Title			
BLOCK DIAGRAM & PAGE INDEX			
Size	Document Number	Rev	
A2	S15	-1	
Date	Friday, December 12, 2008	Sheet	1 of 50

Wistron Incorporated 21F, 88, Hsin Tai Wu Rd Hsichih, Taipei	
Title REVISION HISTORY	
Size A2	Document Number S15
Date Friday, December 12, 2008	Sheet 2 of 50
Rev -1

<Variant Name>		
 Wistron Incorporated 21F, 88, Hsin Tai Wu Rd Hsichih, Taipei		
Title		
MCH DCPL & VGA TERMINATION		
Size	Document Number	Rev
B	S15	-1
Date:	Friday, December 12, 2008	Sheet 21 of 50

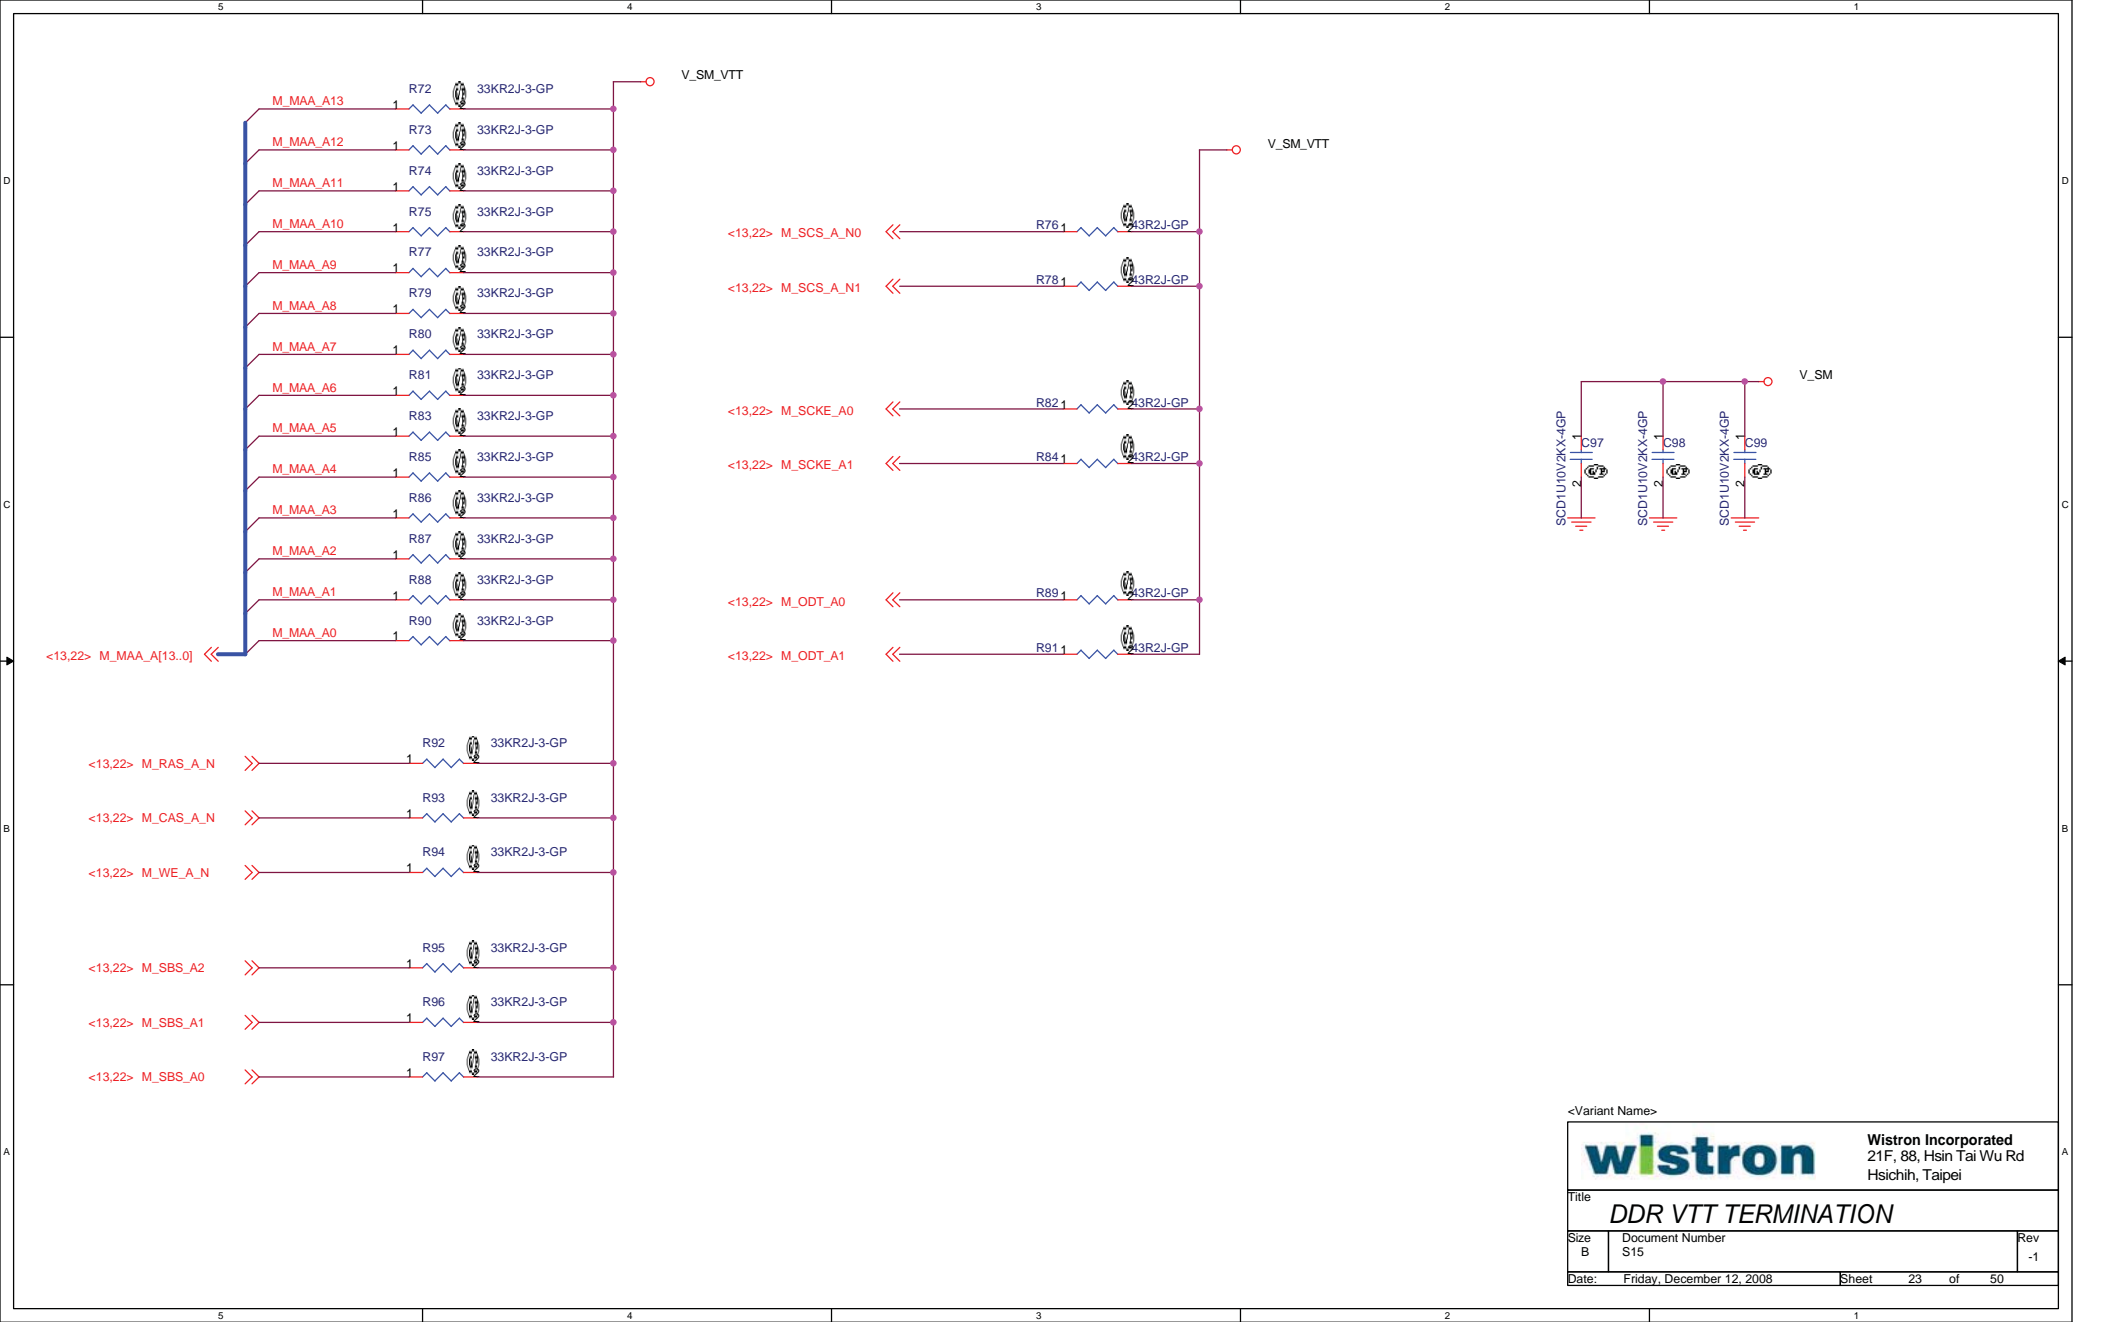
SA-0730-change R69,R70,R71 to 150 Ohm

<Variant Name>		
wistron		
Wistron Incorporated 21F, 88, Hsin Tai Wu Rd Hsichih, Taipei		
File	CK 410	
Size	Document Number	Rev
	CustomS15	-1
Date	Friday, December 12, 2008	Sheet 25 of 50

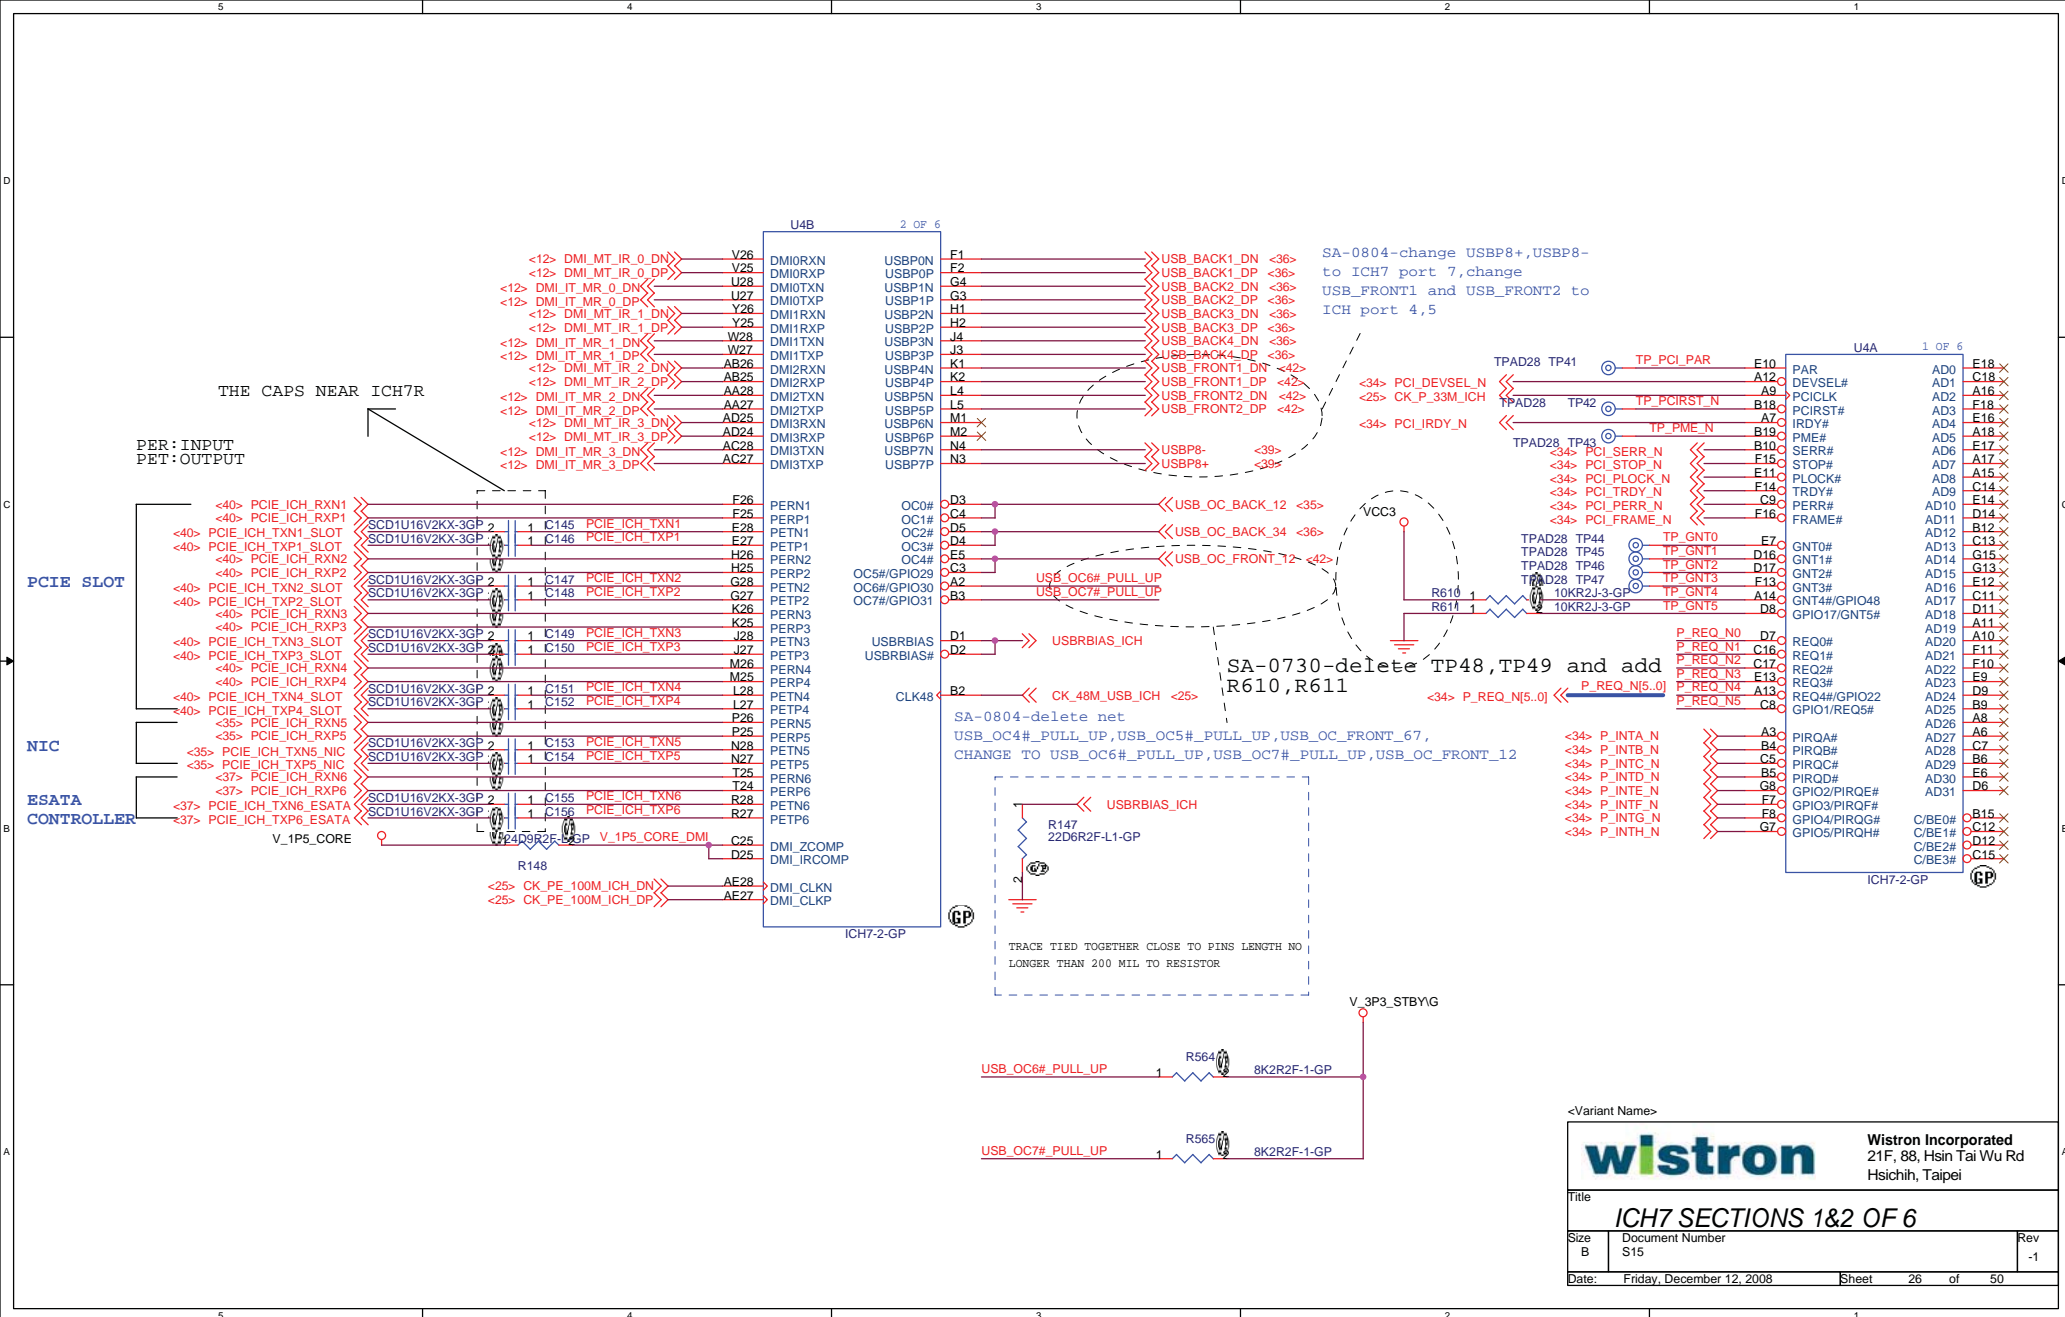
SA-0730-delete Net CK410_VDDPCI, and change to VDD_SRC_CLKA

SA-0730-change R129 to 33 ohm

SA-0730-change R146 to DUMMY

Title ICH PULL UP		
Size B	Document Number S15	Rev -1
Date: Friday, December 12, 2008	Sheet 31	of 50

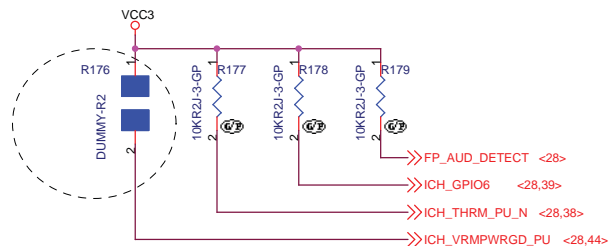
R176 change to Dummy, for VRM's power good already pull high

Title USB CONN		
Size B	Document Number S15	Rev -1
Date: Friday, December 12, 2008	Sheet 36	of 50

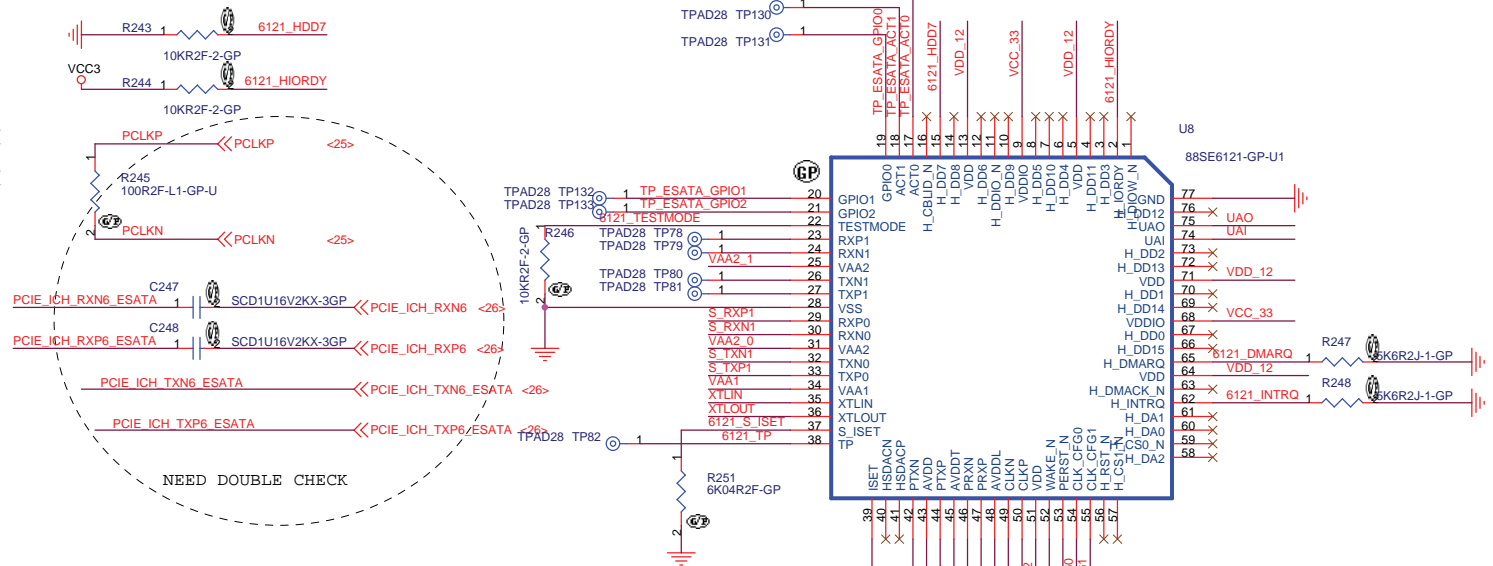
SA-0731-R526 change from 560K to 15K

File
SUPER IO SMSC5127

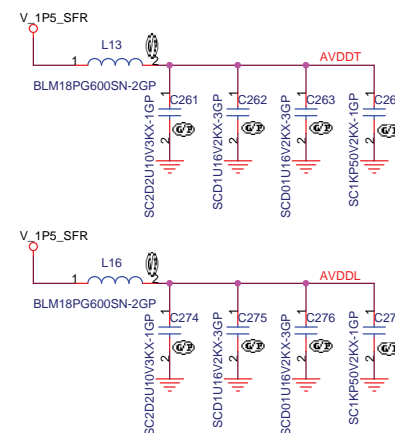
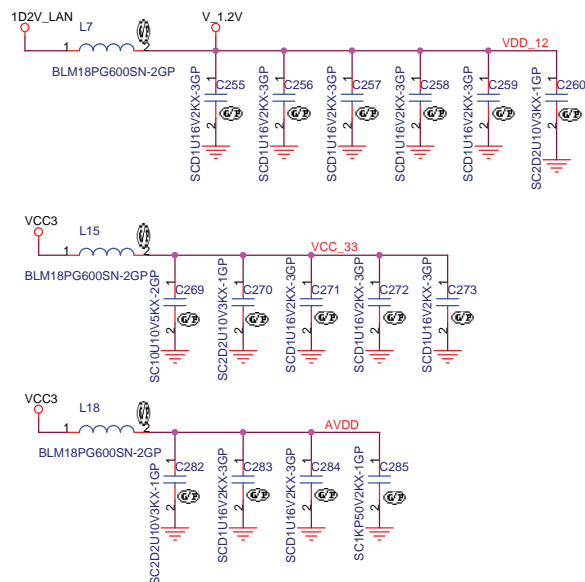
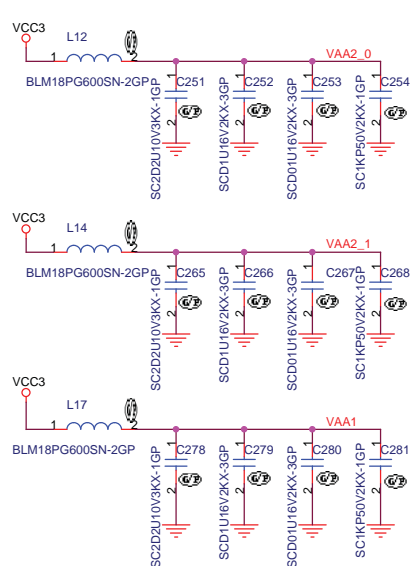
ORCAD SYMBOL IS 88SE6121,BOM SHOULD BE CHANGE
88SE6111 VCC3

SA-0804 Add R226
Dummy, and
connector to
ICH_GPIO12

delete R255,R256

SA-0804-R604 change to Dummy

Add D5,R626(reserved for16.7K),C514(0.1U)
for debounce-circuit

SA-0731 delete R287
SA-0731 change R600 pin2 from net
ICH_VRMPWRGD_PU to ICH_THRM_PU_N

Delete R295,net
H_PROCHOT_N pull
high with R11

According to SMSC5127 Anomaly
sheet,need change
the SMSC5127 0x29 register to
0x86,then the prochot will
inverter to active high to prevent
CPU throttle when booting.

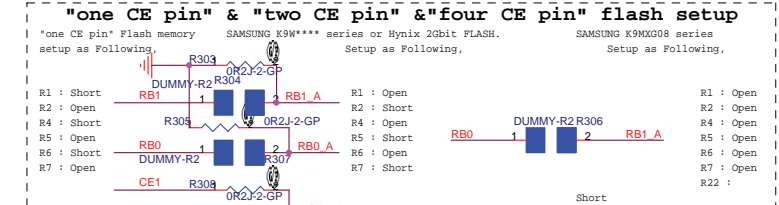
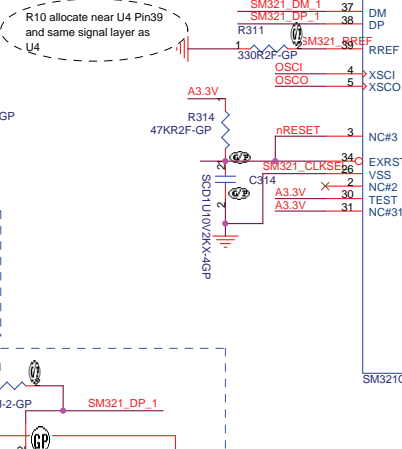
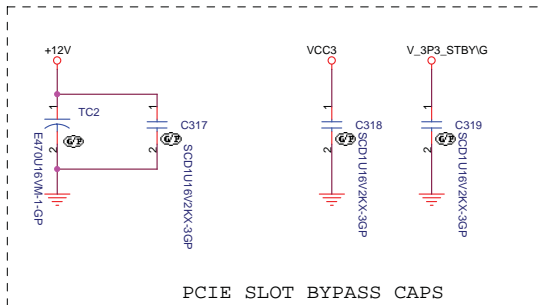
Change NOTE-0116
Delete C14,C19,L2;change
A1.8V power source form
V_FSB_VTT to SMI321 internal
power regulator

Change NOTE-0115
Add L65 for net
A1.8V_SMI321

Change NOTE-0115
net SM321_RV5 connect to TP
and delete R758 and C682

Variant Name:		Wistron Incorporated	
Title		21F, 88, Hsin Tai Wu Rd Hsichih, Taipei	
Size		PCIE & OTHER CONNECTOR	
A3	Document Number	S15	Rev -1
Date:	Friday, December 12, 2008	Sheet	40 of 50

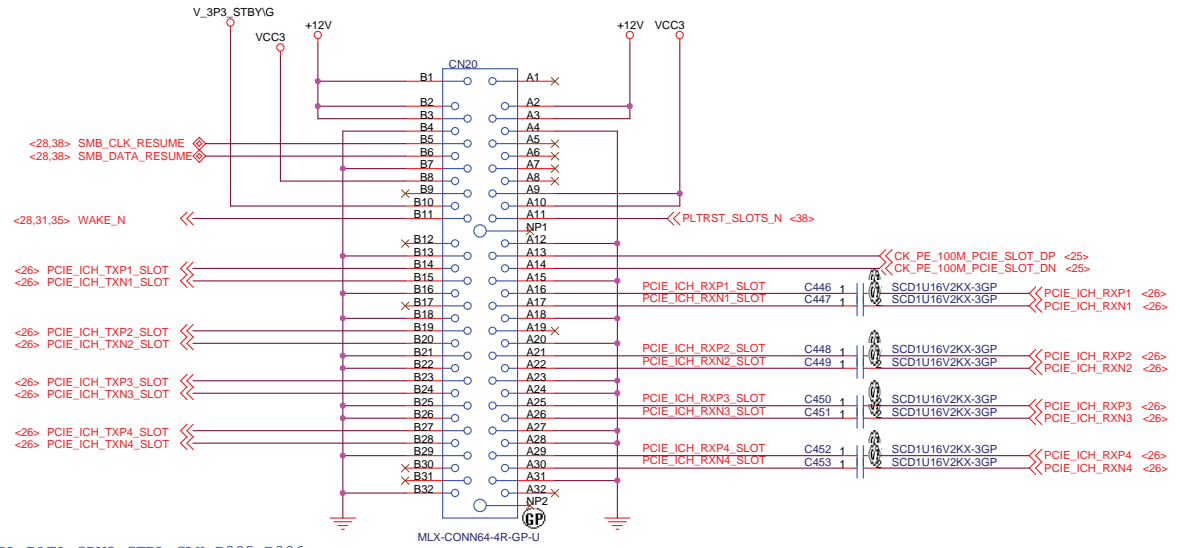
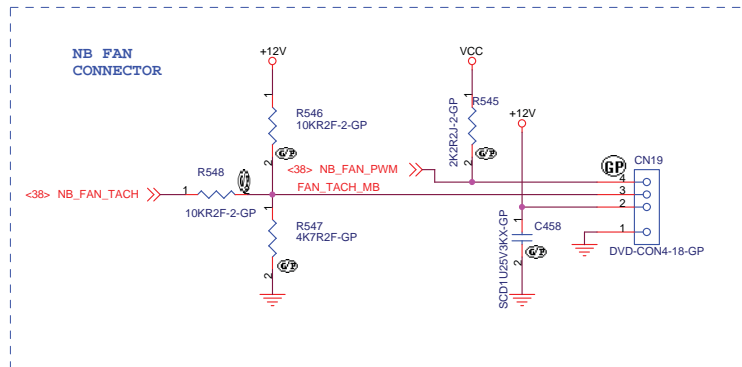
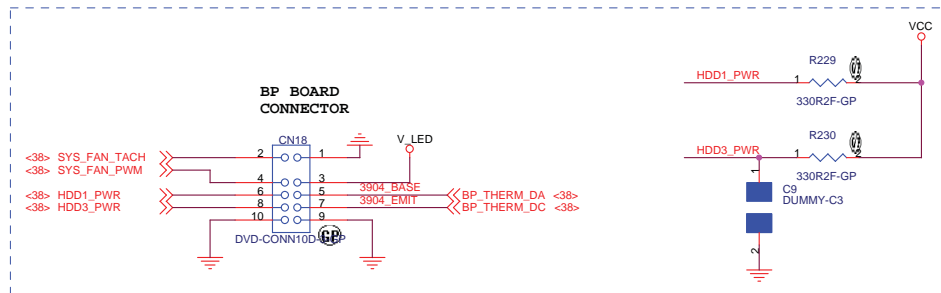
Delete R551(pull high to VCC3)-0812

Delete net SDVO_CTRL_DATA,SDVO_CTRL_CLK,R325,R326

<Variant Name>		Wistron Incorporated	
		21F, 88, Hsin Tai Wu Rd Hsichih, Taipei	
Title			
DEBUG BD CONNECTOR			
Size B	Document Number S15		Rev -1
Date:	Friday, December 12, 2008	Sheet	41 of 50

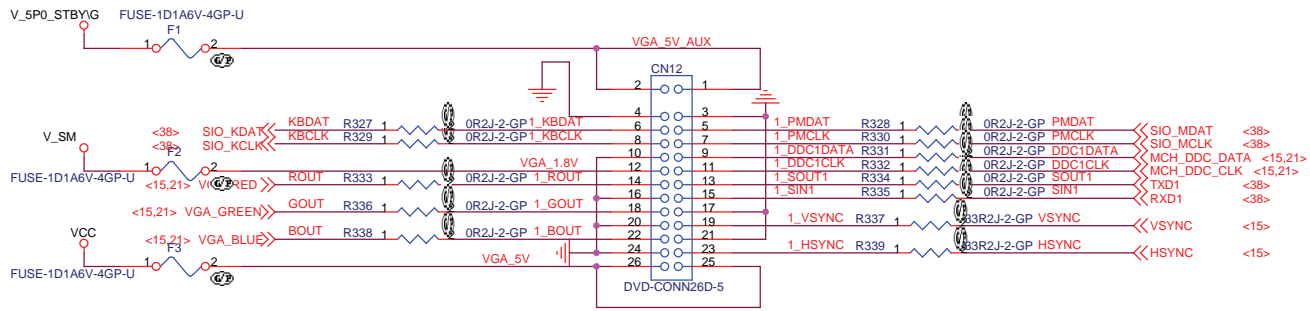
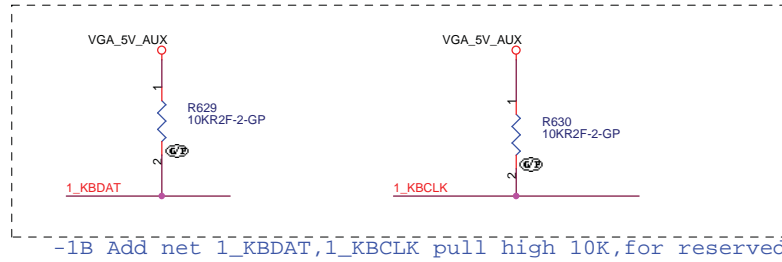
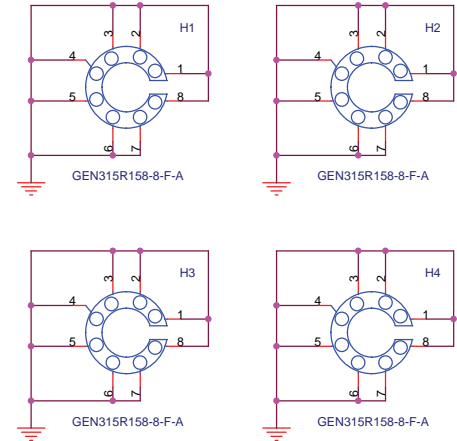
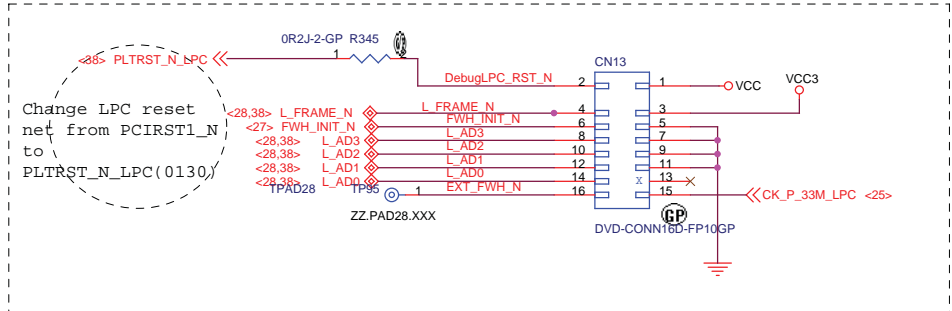
SA-0730-change R340,R342,R344 to 150 Ohm

Title **POWER DECOUPLING & STITCHING**

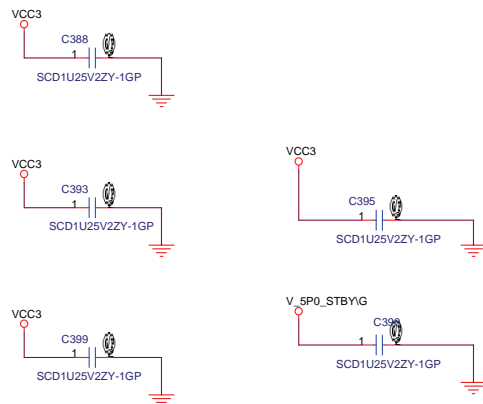
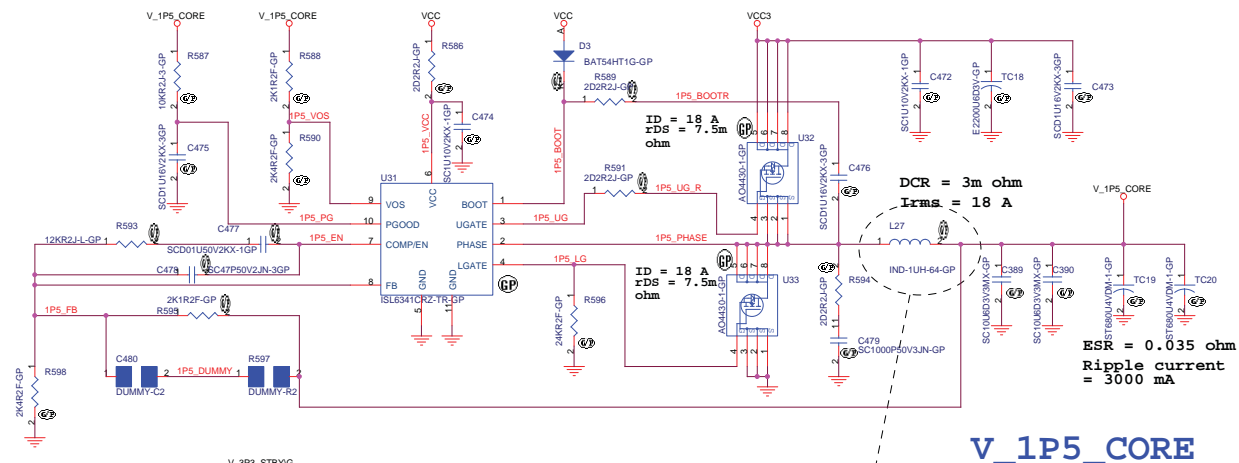
Add stitching caps
C515, C516, C517, C518

SA-0725-Add C493-C509 for EMI solution

Add C519
